Info Only: Comments from Service
Engineering and Stormwater Engineering
are in blue text.

Flying Horse North Filing No. 4 Final Drainage Report

September 2024

PCD File No. SF

Culvert Report

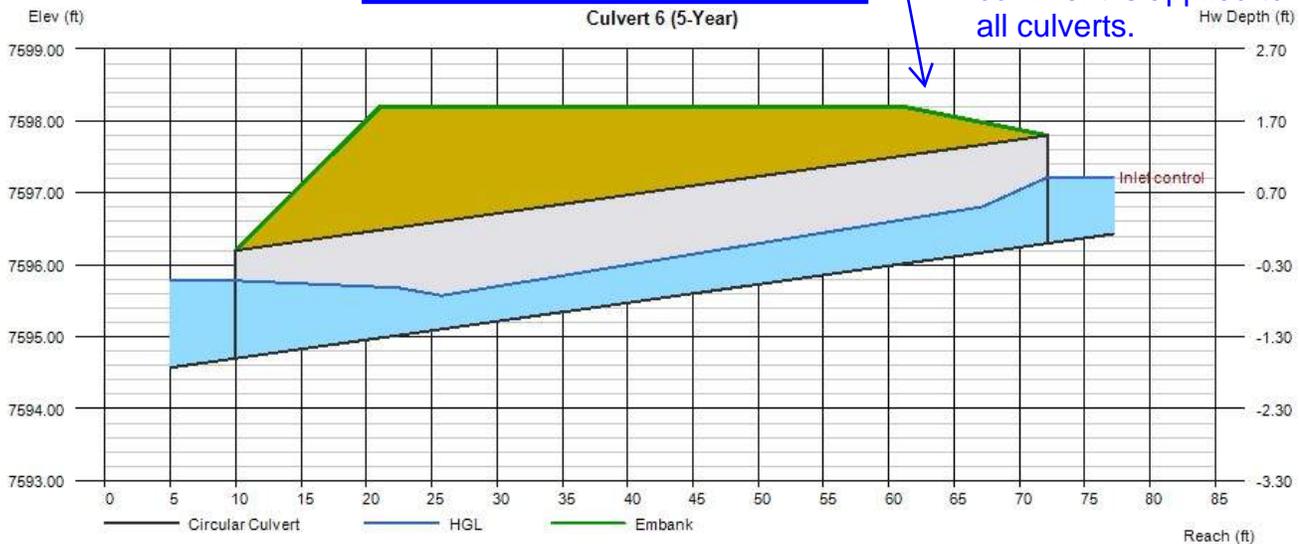
The burial depth must be at least 2 feet for all culverts. Please update the CD accordingly. This comment is applied to all culverts.

HRG Response: The culverts have been updated to have a burial depth of at least 2' under roadways.

Culvert Report

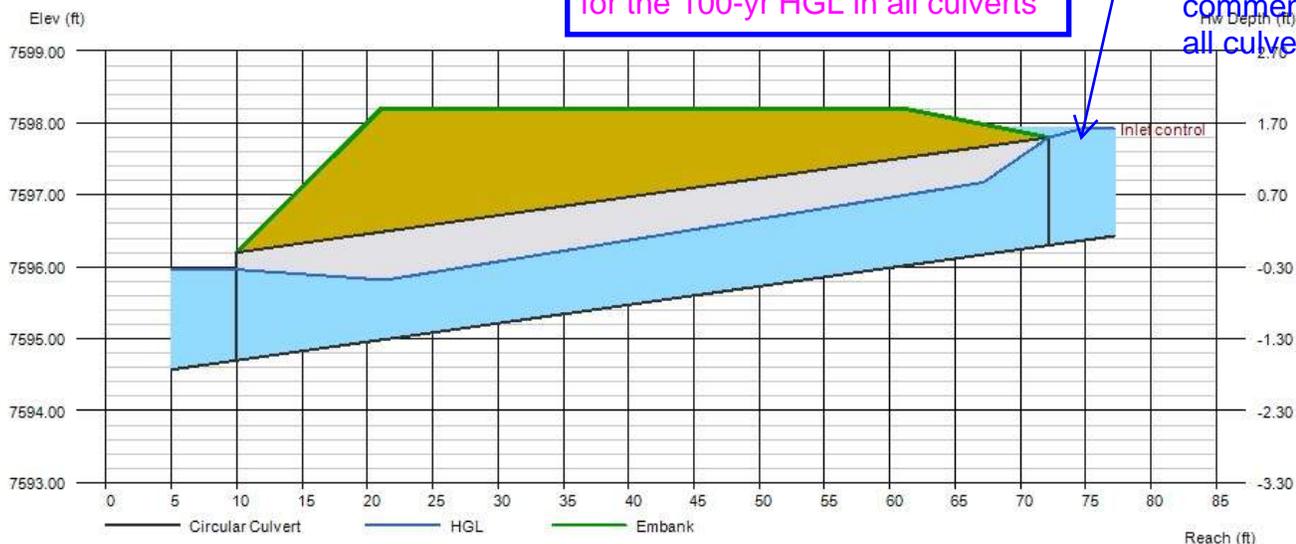
100 yr must be at least 1ft below the ground. This comment is applied to all culverts.

HRG Response: The culverts have been updated to have a burial depth of at least 2' under roadways. This change now allows for at least 1' of freeboard for the 100-yr HGL in all culverts
